Technical Bulletin

Summary of issue: SpectrAlert® Advance Mini-horn – Inability to Silence

Model Numbers: MHR, MHW

4 digit date code location

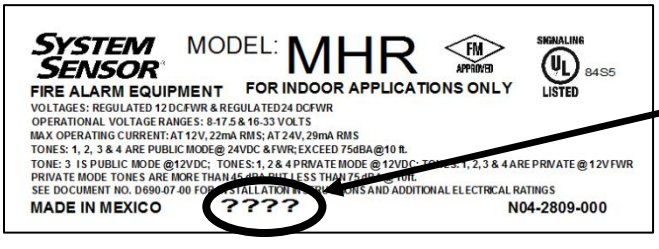
Manufactured date range: October 1 2014 (4101) to March 17 2015 (5033)

4101 defined as 4 = 2014, 10 = October, 1 = 1st week of the month
5033 defined as 5 = 2015, 03 = March, 3= 3rd week of the month

System Sensor has identified an issue with the Mini-horn models MHR and MHW when the silence feature is used. Products manufactured within the date codes specified above may not silence when the silence feature is activated on the Fire Alarm Control Panel. Date codes outside of this range are not affected.

This issue does not affect product performance for sounding and notification. System Sensor has implemented a change to correct this issue on date codes 5034 and beyond.

The commissioning, annual inspection, and testing of each Mini-horn must be conducted in the manner in which it was designed to operate as described in NFPA 72® and local AHJ requirements. Mini-horns that have been installed, tested and are not exhibiting this issue need not be replaced. If you are experiencing the condition described, System Sensor will honor its warranty return policy and is recommending that products exhibiting this issue within the date codes specified above be replaced and returned through normal channels.
